# CROSSROADS MIXED USE FILING NO. 1

## COUNTY OF EL PASO, STATE OF COLORADO STORM SEWER PLANS

UNDERGROUND DETENTION  
DECEMBER 2022

CROSS ROAD MIXED USE FILING NO.1		TITLE SHEET		DATE: 12-23-22		SHEET 1 OF 6		SI01	
PROJECT NO. 18-003		SCALE: HORIZONTAL: N/A VERTICAL: N/A		DESIGNED BY: GT		DRAWN BY: TAU		CHECKED BY: VAS	
212 N. WAHSATCH AVE., STE 305 COLORADO SPRINGS, CO 80903 PHONE: 719.955.5485									
FOR AND ON BEHALF OF M&S CIVIL CONSULTANTS, INC.		VIRGIL A. SANCHEZ, COLORADO P.E. NO. 37160							
REVISED:	NO.	DATE:	BY:	DESCRIPTION:	DATE:	BY:	DESCRIPTION:	DATE:	BY:
THE ENGINEER PREPARING THESE PLANS WILL NOT BE RESPONSIBLE, OR LIABLE FOR, UNAUTHORIZED CHANGES TO OR USES OF THESE PLANS. ALL CHANGES TO THE PLANS MUST BE IN WRITING AND MUST BE APPROVED BY THE PREPARER OF THESE PLANS.									
CAUTION

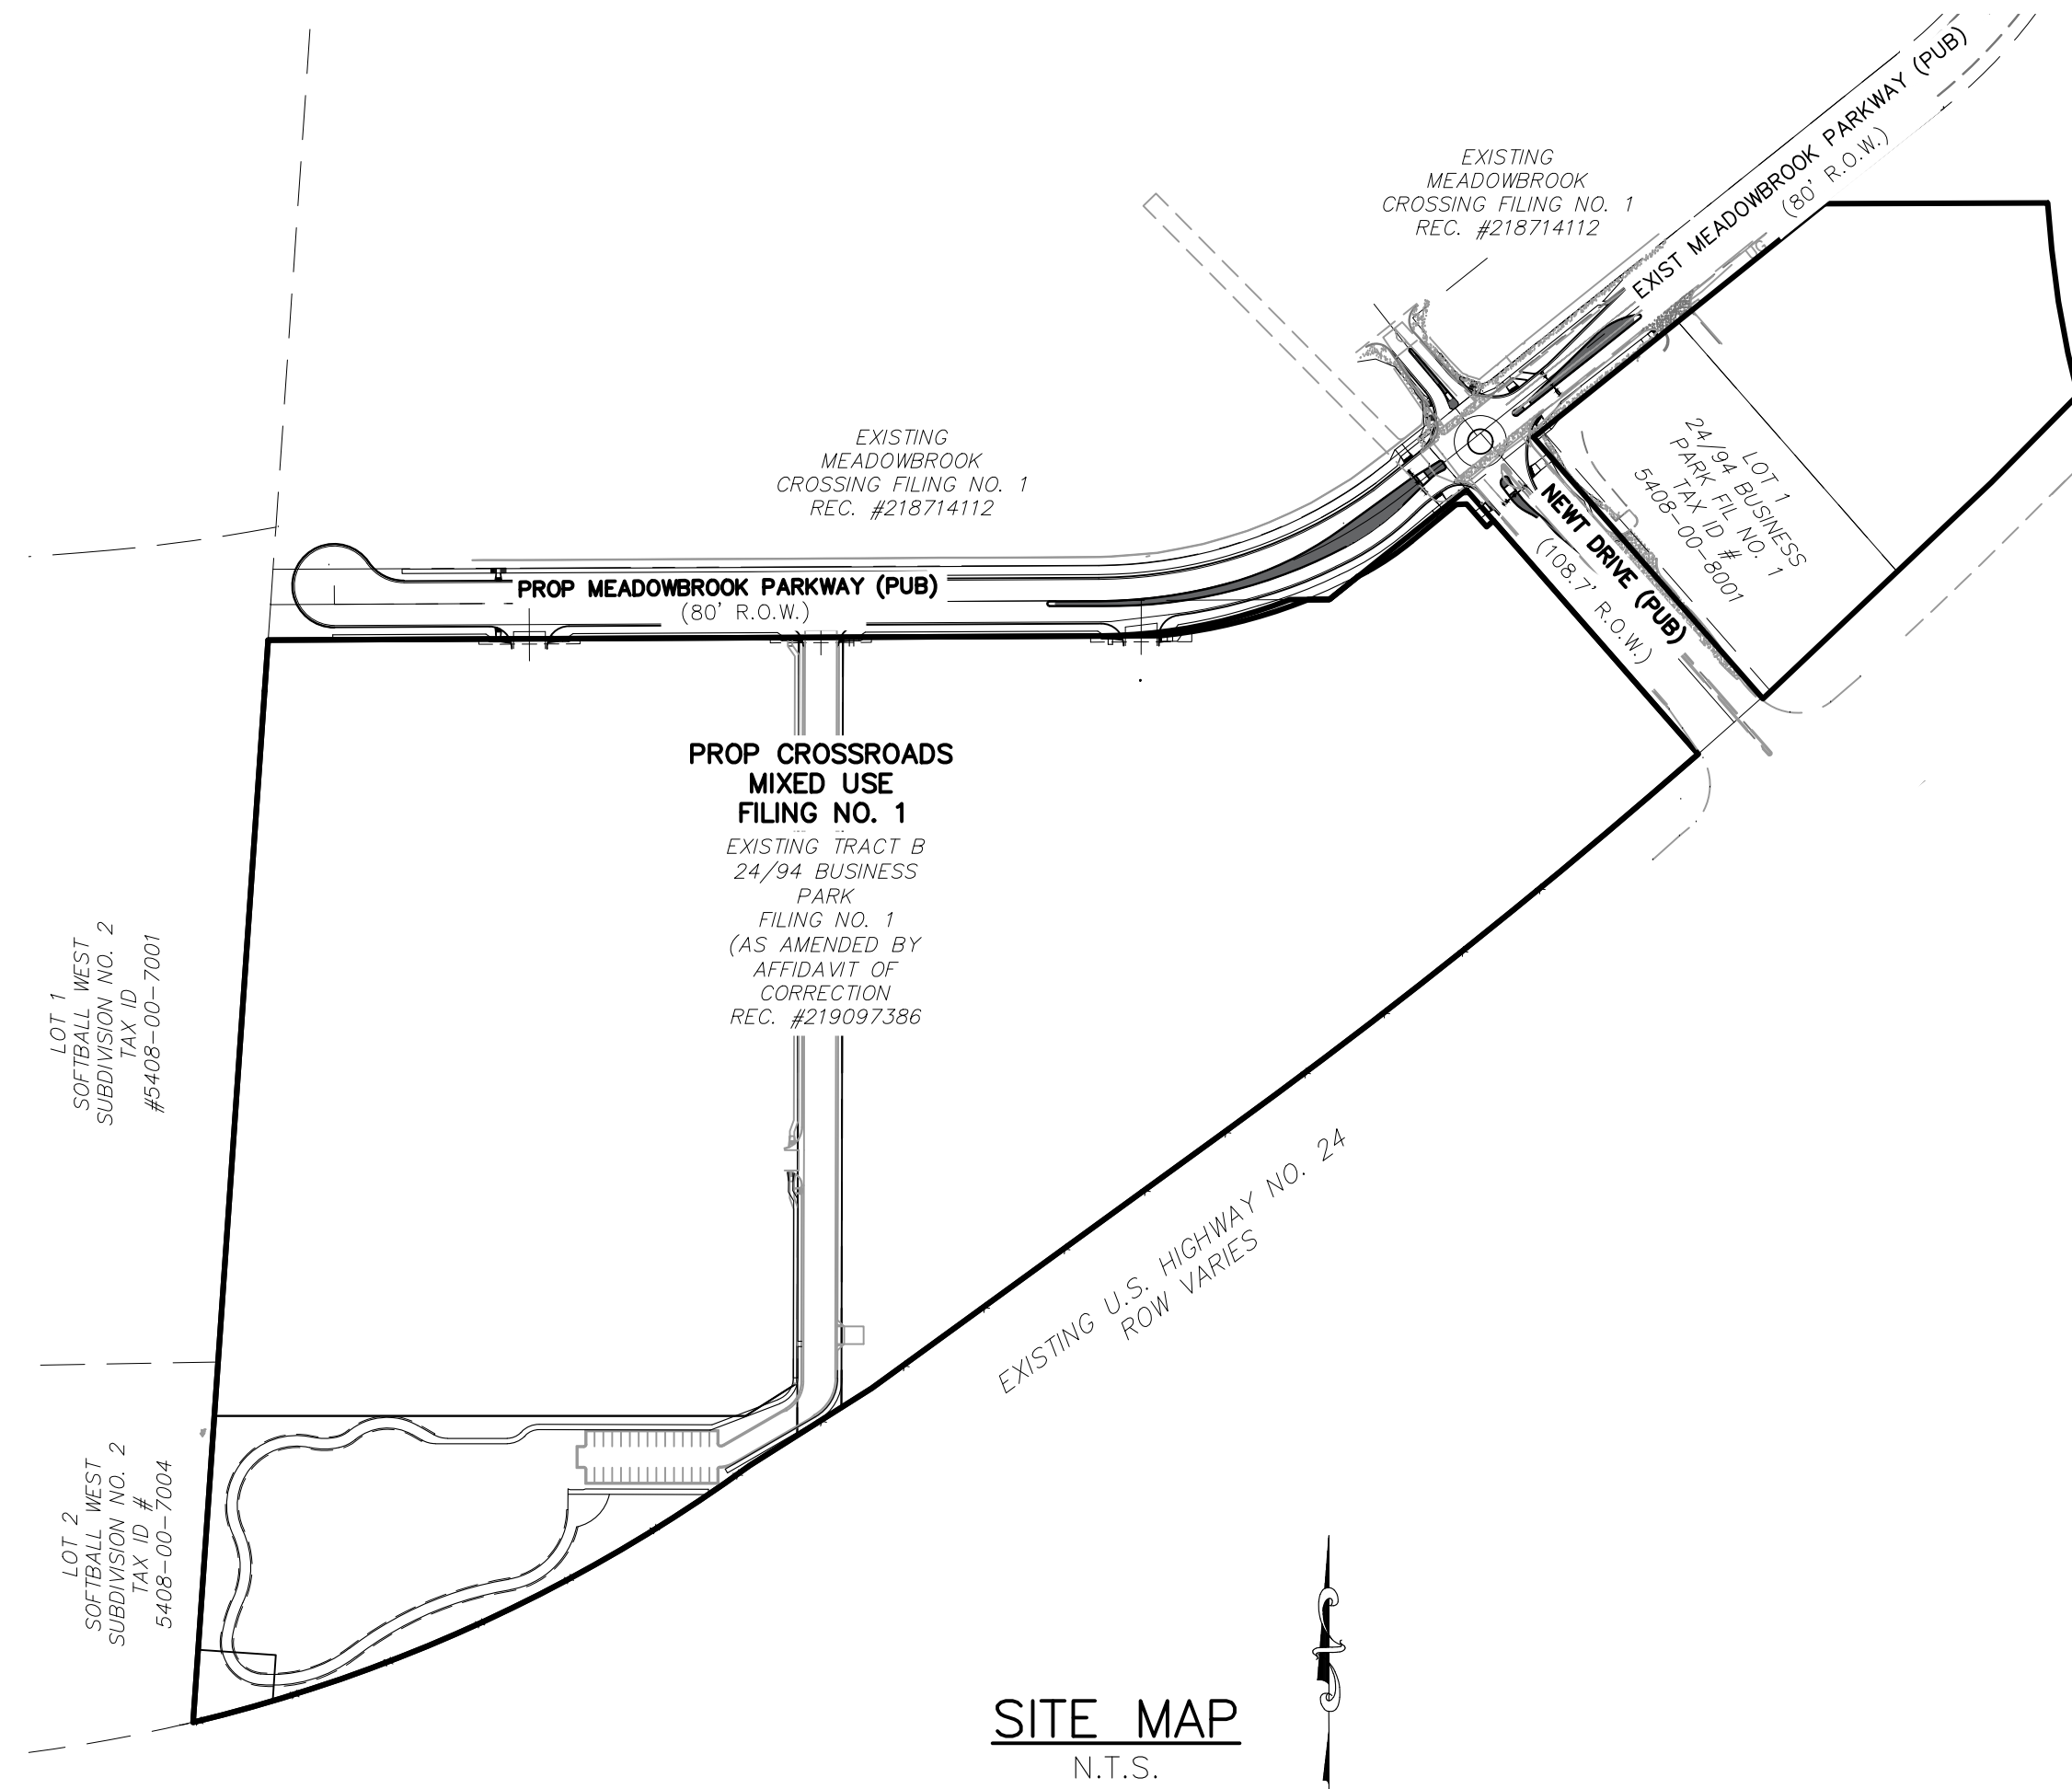
Provide an updated grading and erosion control plan

Add Sheet ST07

Add "CDR-23-002"

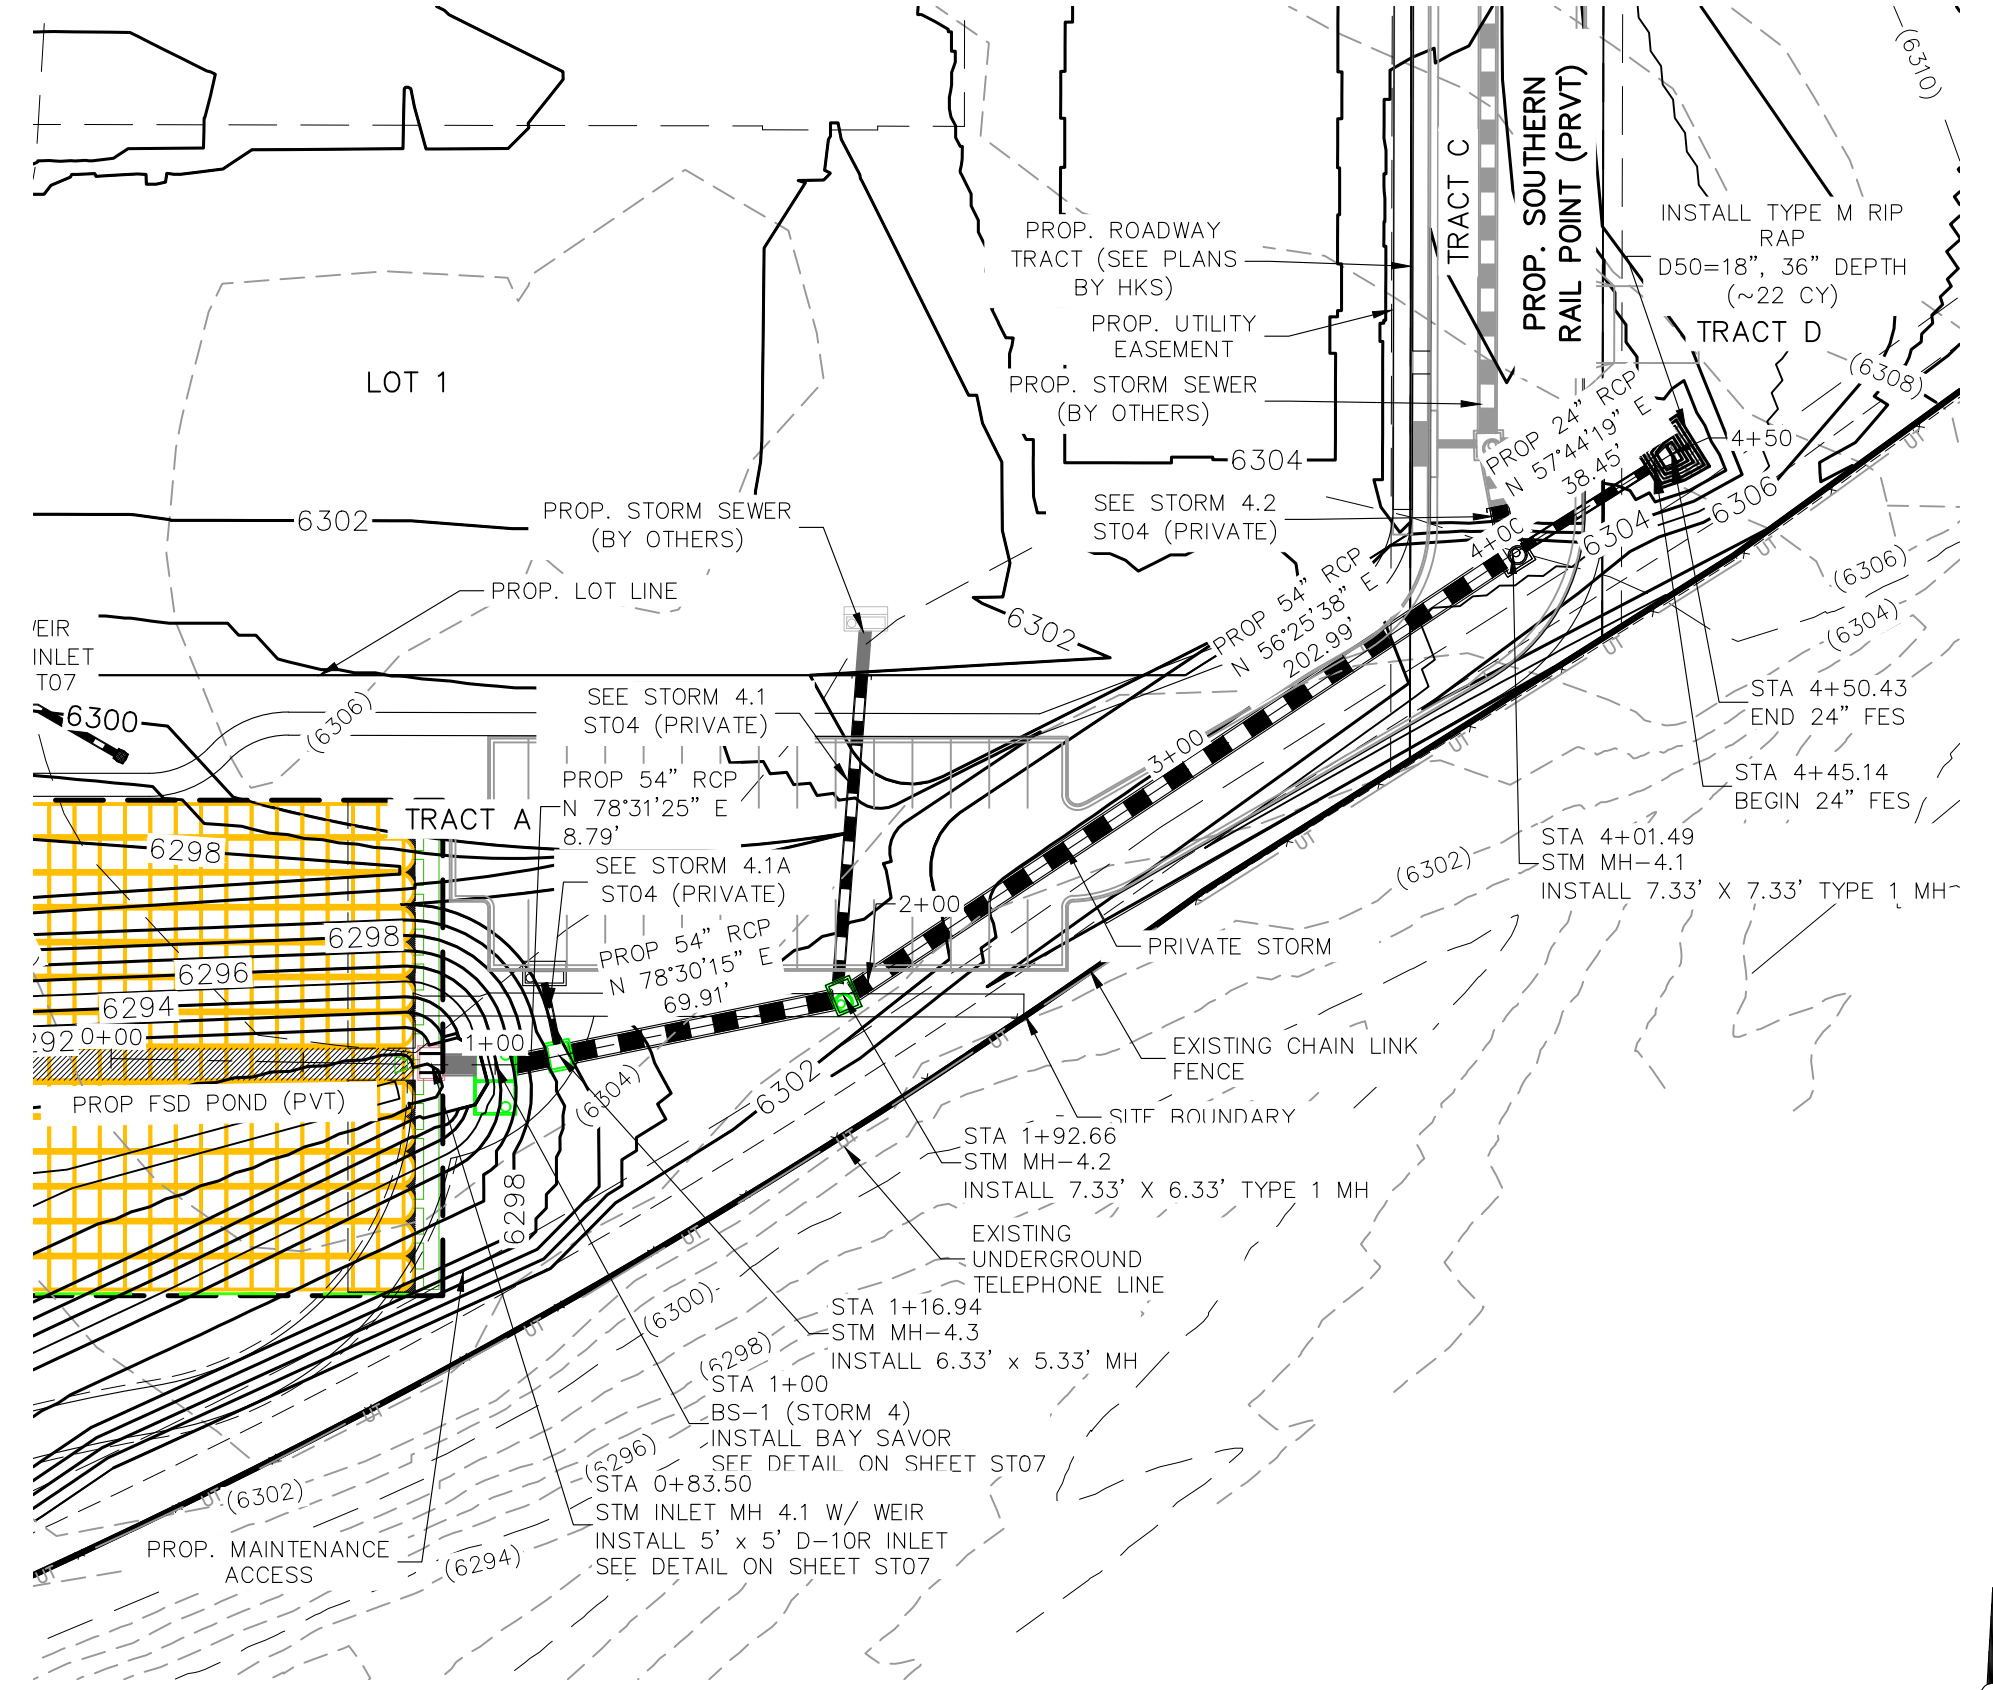
Remove. This was the previous EDB Spillway. This is no longer necessary.

Update proposed contours to reflect the updated design.

Delete or provide clarification. This appears to be a remnant note from the previous design.

Update proposed grade.

**STORM 4.1A (PRIVATE)**  
**STA 1+00.00 TO STA 1+20.80**

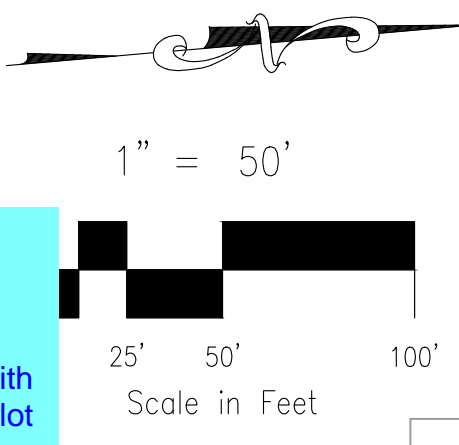
Drainage letter identified this as future parking overflow.  
Revise design. An interim drainage solution should be presented. The final configuration with the D-10R inlet should be a part of the parking lot site plan approval.

**CONCEPTUAL LAYOUT**

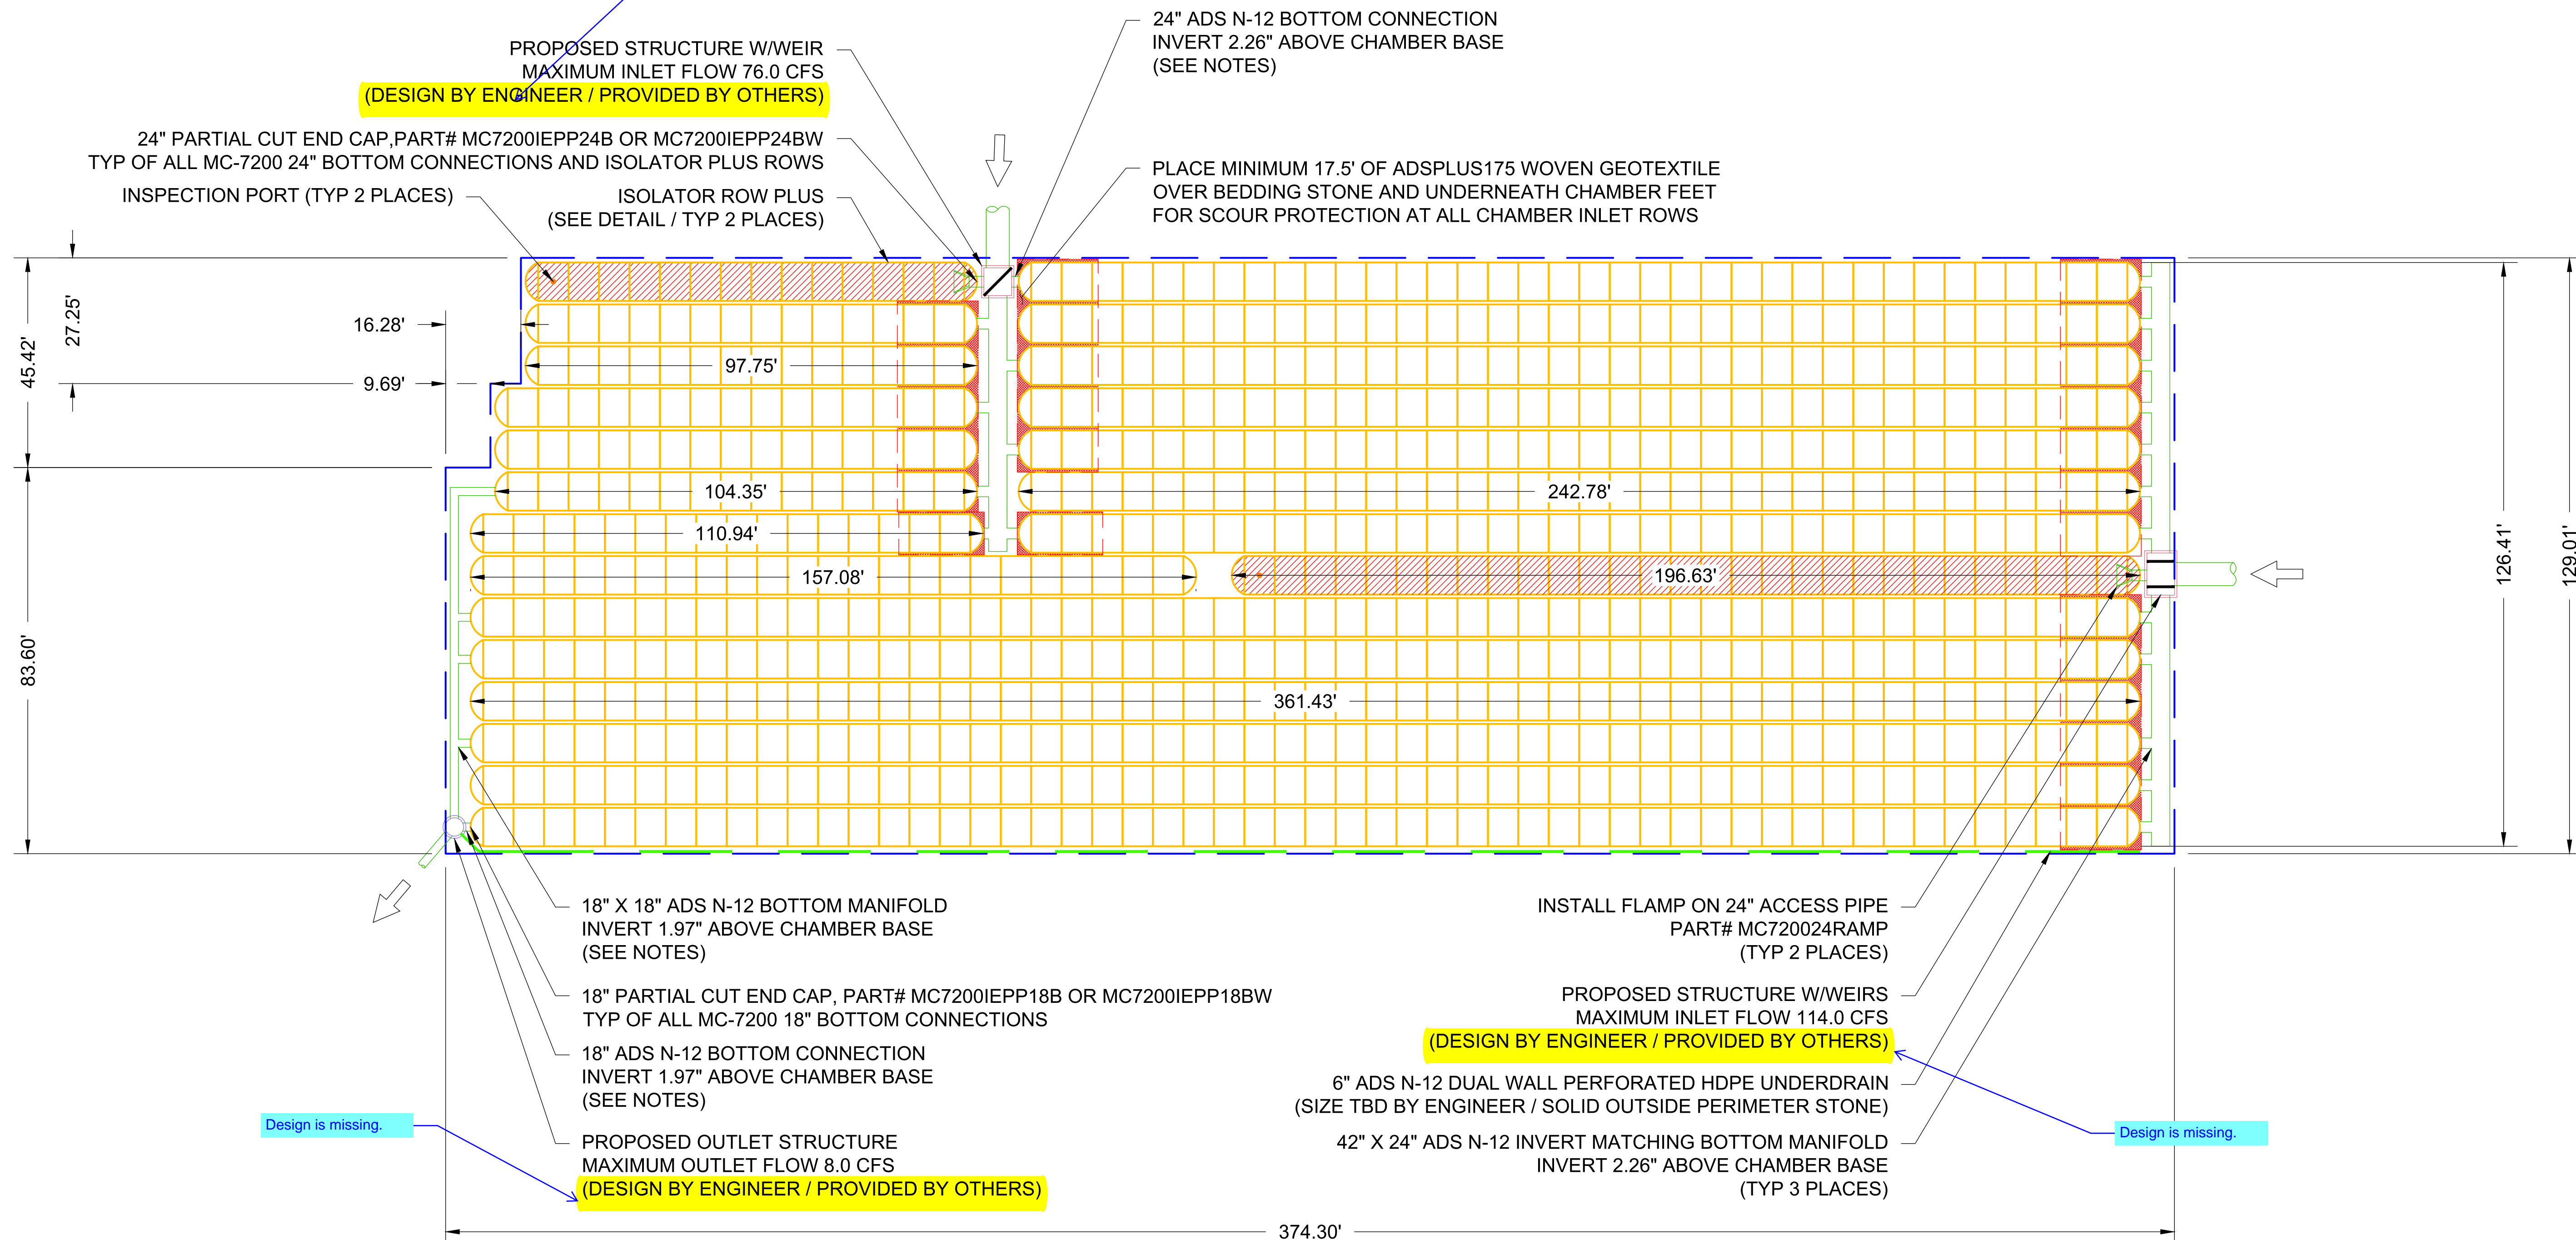
Provide the geotech analysis that addresses this note.

The associated geotech report submitted with the final plat (SF2129) only discussed aboveground detention, and not the underground system.

The plans needs to be updated to reflect the required base stone depth.
